RECEIPT DATE: 12/20/16 **ONSITE SEWAGE DISPOSAL SYSTEM** P 5-59883

PROPERTY ADDRESS: 13548 Mitchells Way W. Friendship, MD 21794

RE: 13548 Mitchells Way
West Friendship, MD 21794
"OSDS Plan"

I have reviewed the OSDS Plan for Cloverfield Sec. 1 Lot 8 and here are my comments.

Red Lined 1/9/17
RFE

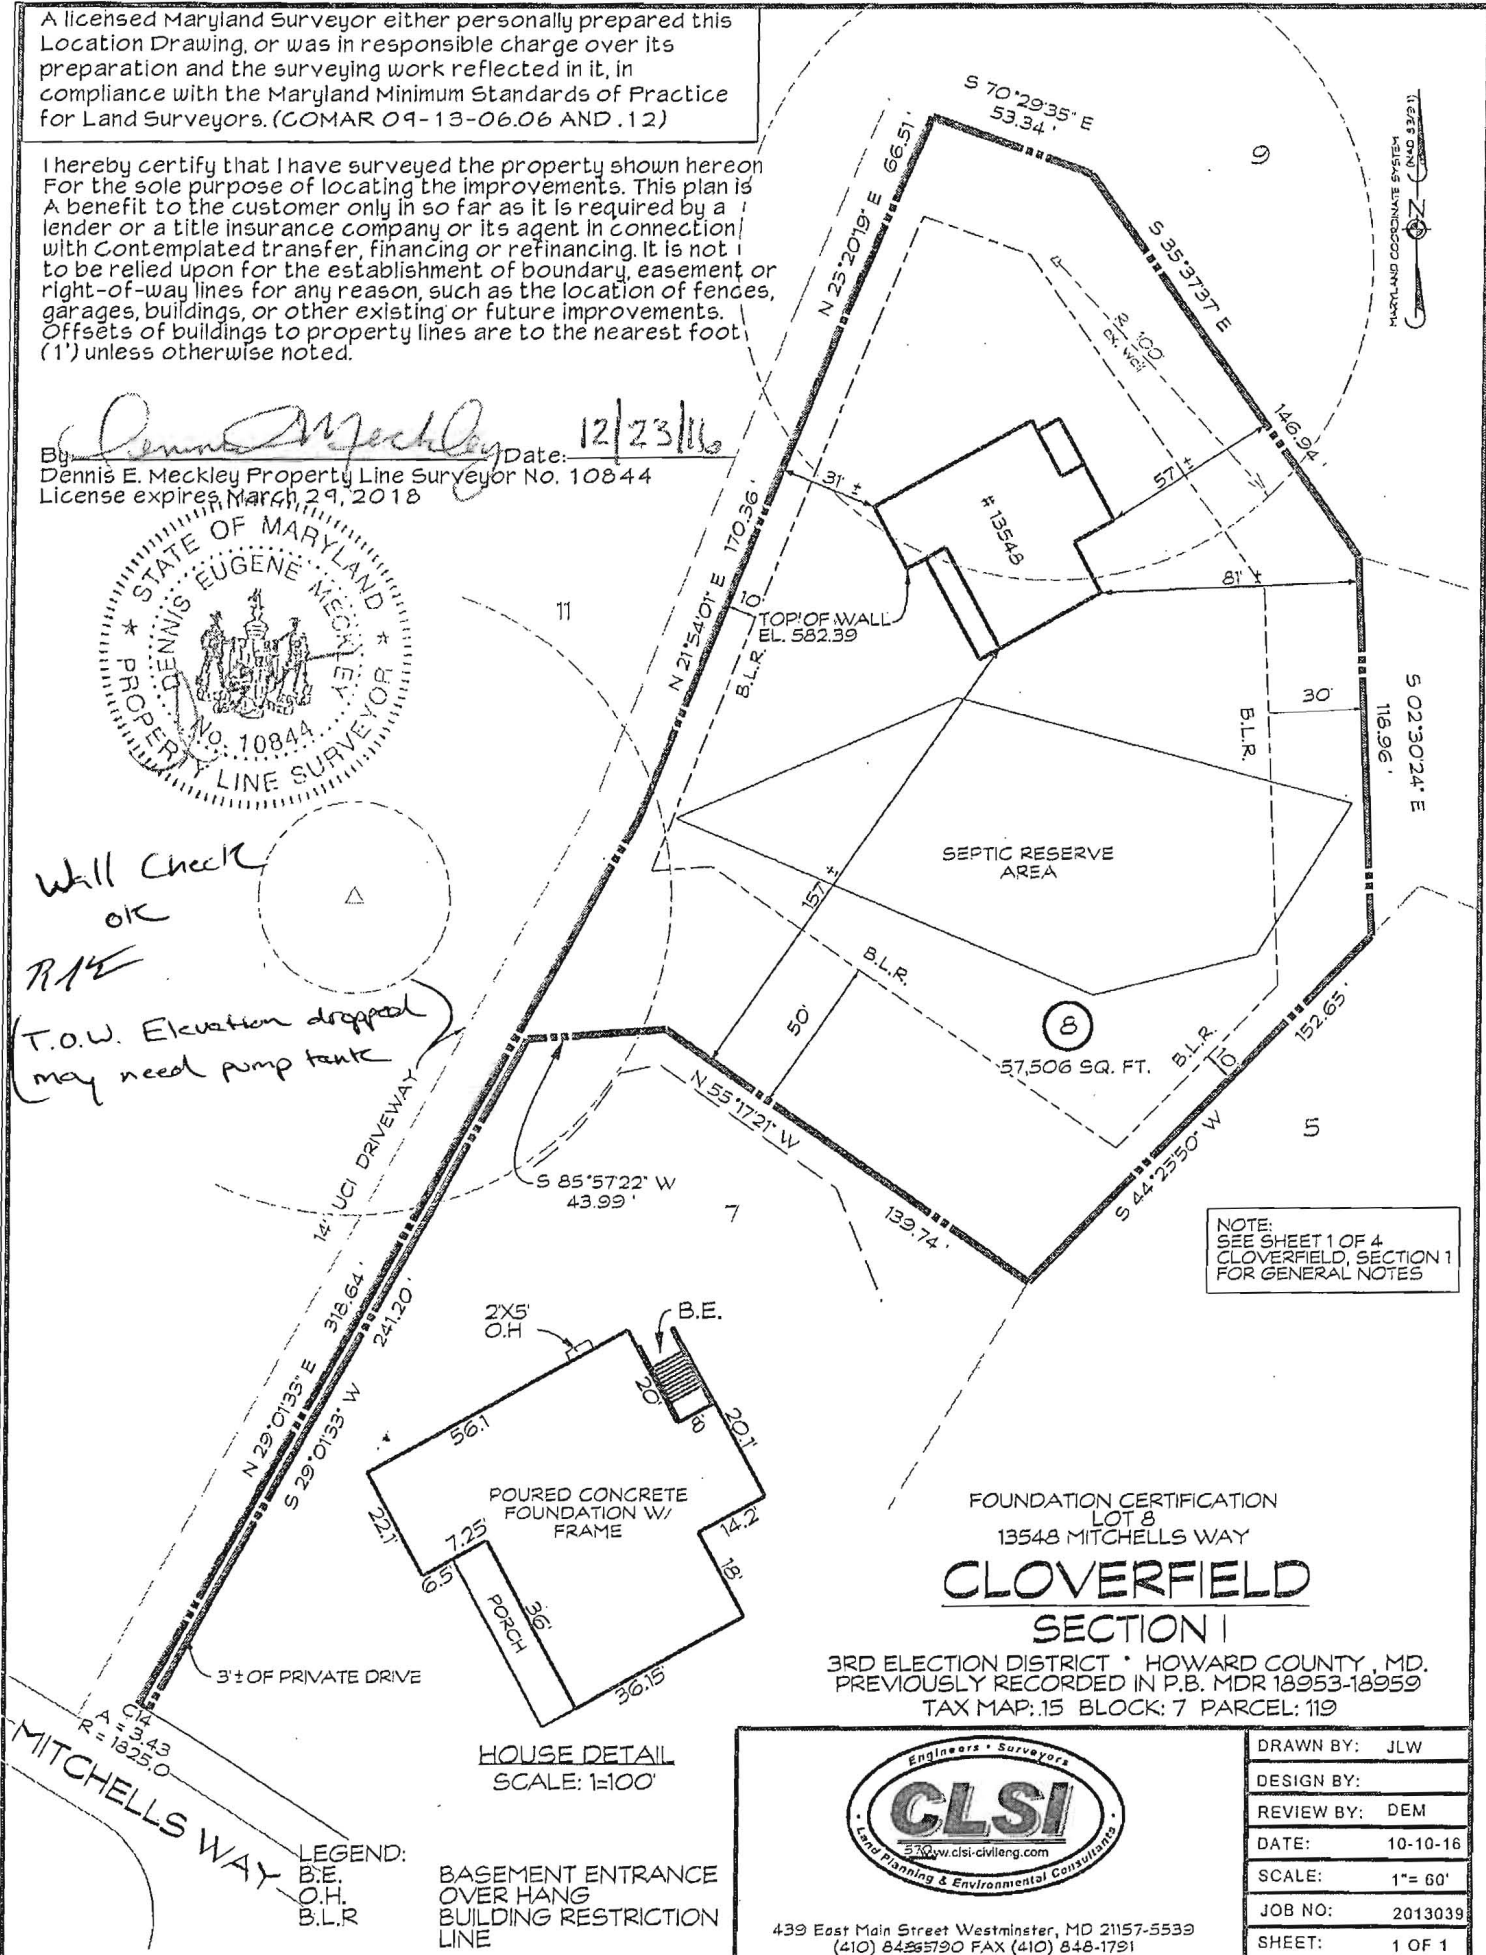
- The internal wall separating the two compartments cannot contain a baffle. There must be a 2 inch slot.
- The inlet vertical baffle must be 6 inches in diameter.
- Ex. Well needs to be visible.
- Relative replacement trench elevations need to be shown.

FOUNDATION CERTIFICATION
 LOT 8
 13548 MITCHELLS WAY
CLOVERFIELD
 SECTION I

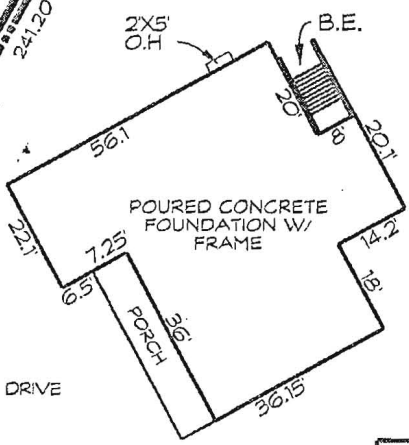
Wall Check
 OK
 RAE
 (T.O.W. Elevation dropped
 may need pump tank)

ONSITE SEWAGE DISPOSAL SYSTEM
DESIGN PLAN AND PLOT PLAN
SPRING MILL LLC
13548 MITCHELLS WAY
TAX ACCOUNT NO.: 34-8830
LOT 3

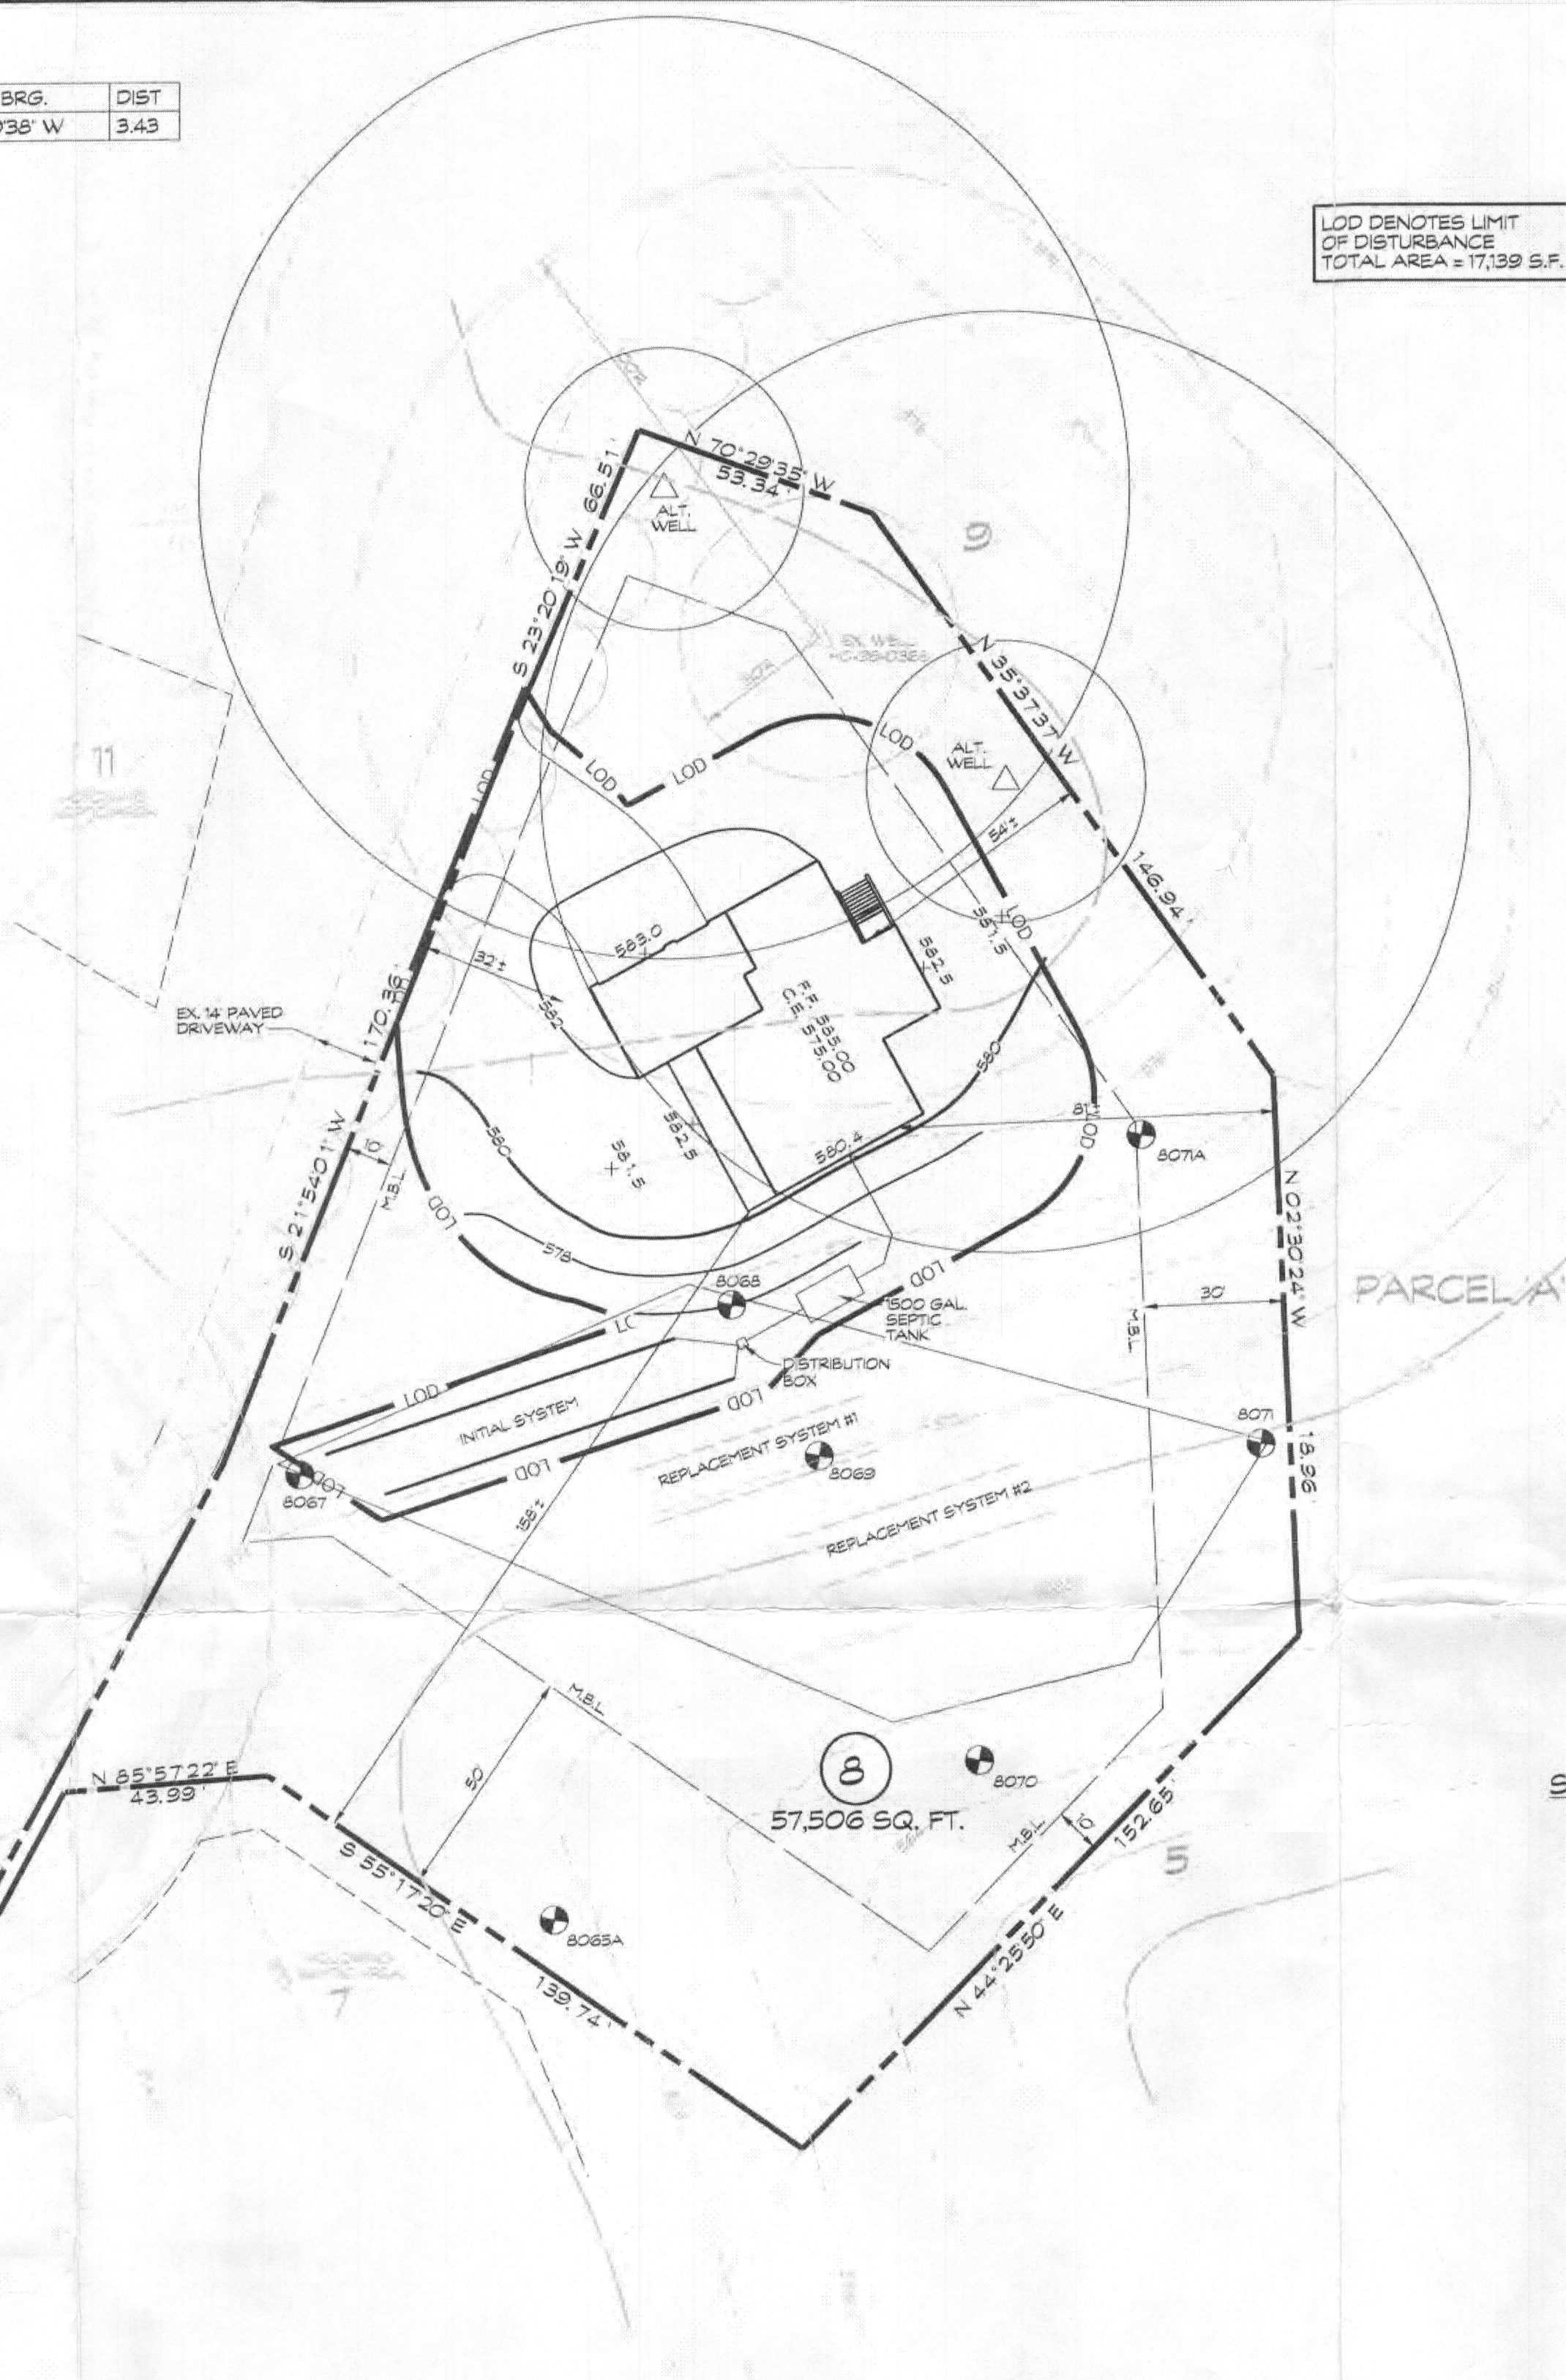
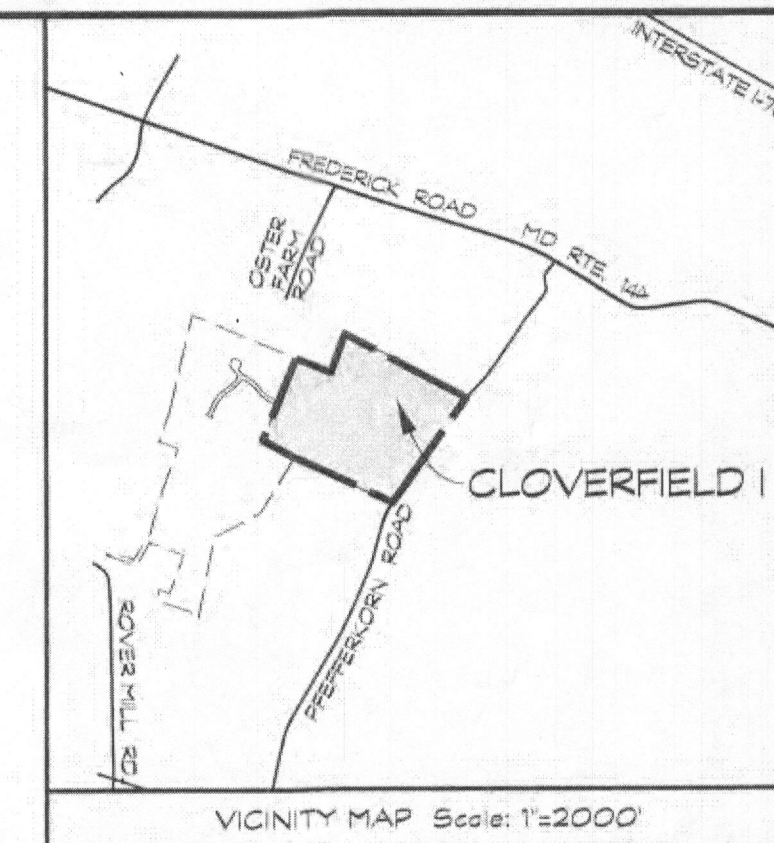
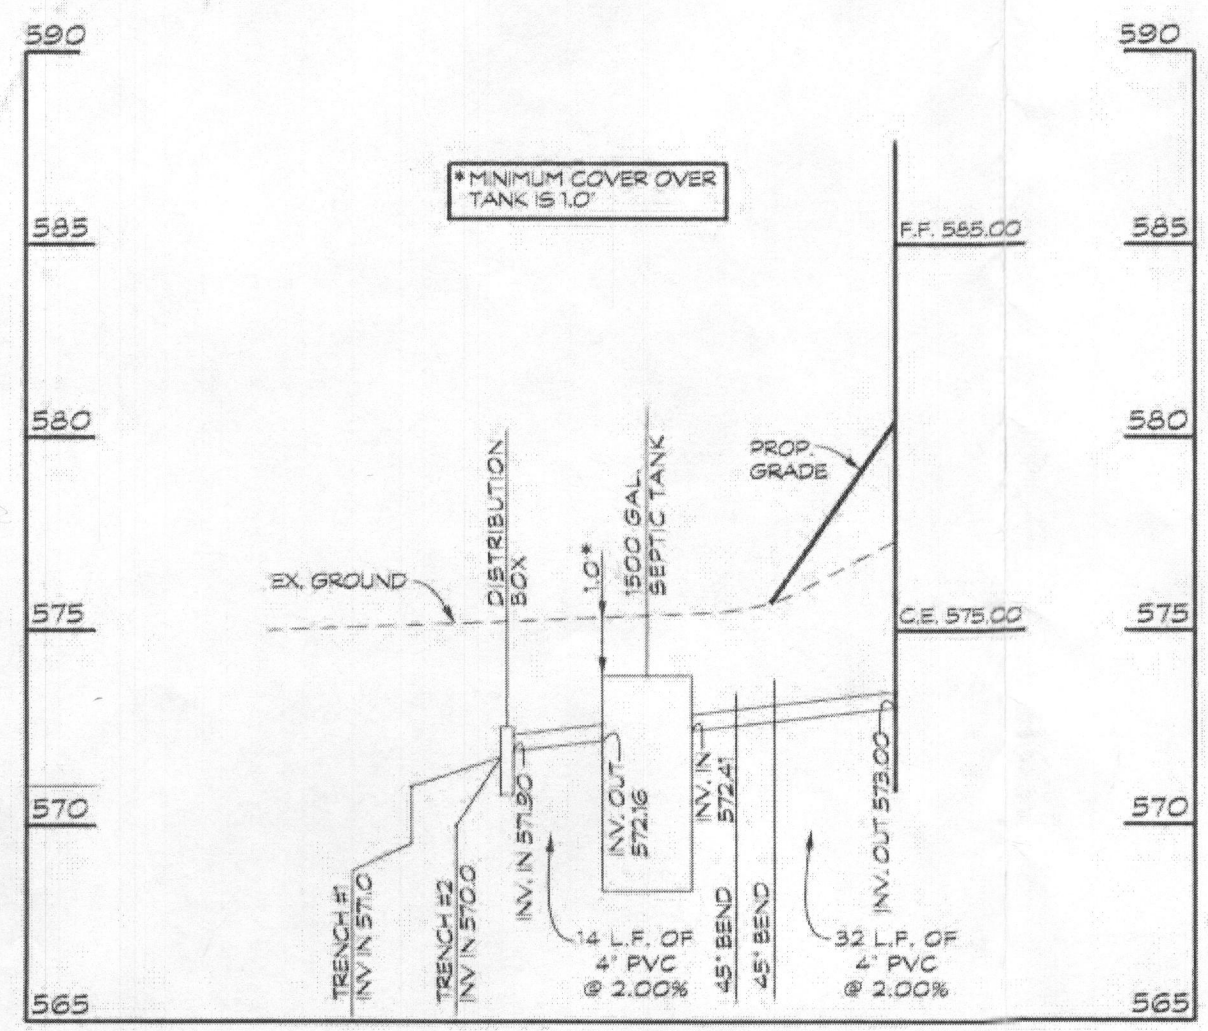
Hey Linda,
Instead of having new plans submitted for Cloverfield Lot 8 would it be ok with you if I red lined the plan for you? I would only need to red line the 2 inch slot in the septic tank and the inlet vertical baffle to a 6" diameter. Let me know if you have any questions. Thanks.

- The internal wall separating the two compartments cannot contain a baffle. There must be a 2 inch slot.
- The inlet vertical baffle must be 6 inches in diameter.
- Ex. Well needs to be visible.
- Relative replacement trench elevations need to be shown.

Date	Revisions	Drawn By: BM
7/26/16	REVISED PER ROBERT FREEMAN EMAIL DATED 7/7/16	Designed By:
12/8/16	REVISED BAT TANK TO SEPTIC TANK	Reviewed By: LDA
		Date: 6/16/16
		Scale: AS SHOWN
		Job No.: 2013039
		Sheet: 1 OF 1
